# WRITTEN STATEMENT OF CONDITIONS

The City of North Richland Hills received this plat on January 18, 2023. The Development Review Committee reviewed this plat on January 31, 2022. The following represents the written statement of the conditions for conditional approval of the plat.

MINOR PLAT  
LOTS 1 & 2

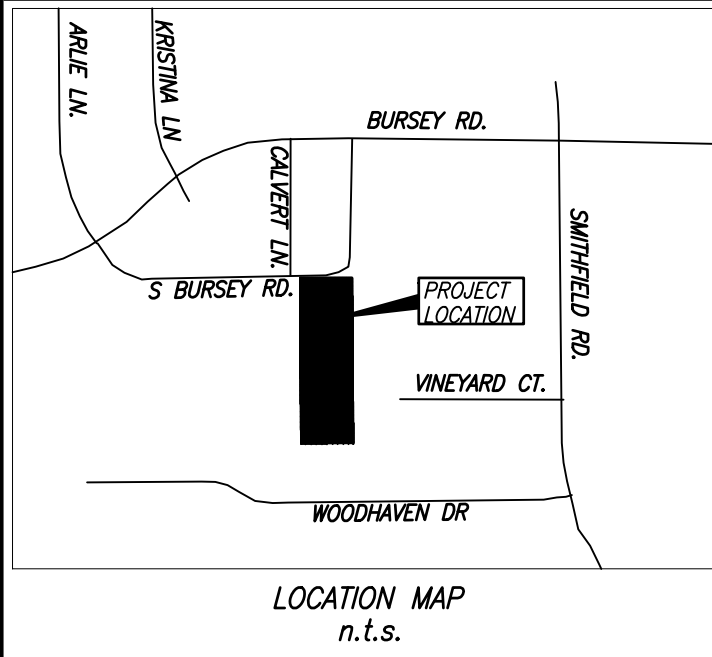
The Development Review Committee (DRC) cannot support the width of the leg on the southern lot as proposed. The DRC would support and recommend approval of a waiver of the 50-foot width for the portion of the leg to provide for a minimum six-foot building setback adjacent to the existing house, provided the remainder of the leg complies with the 50-foot width. The purpose is to ensure that the existing structures can satisfy all building setbacks from the new property lines and prevent the house from becoming nonconforming in terms of setbacks. See exhibit to right as a guide.
